MODIFICATION BULLETIN

AIRPL
MODEL
91B

91.6/8

Engine mounting. Moving of manufacturing plate

Engine mounting 91.6312

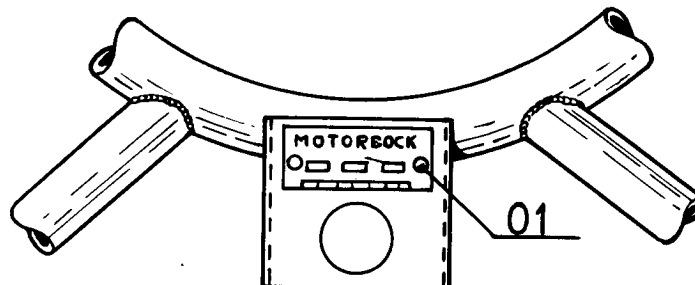
Due to corrosion having occurred underneath the manufacturing plate for the engine mounting this plate should be moved to the bracket for the mixture control.

Remove the manufacturing plate and clean the engine mounting free from corrosion and apply protective paint.

Secure the manufacturing plate to the bracket for the mixture control on the underside of the mounting in accordance with the figure below.
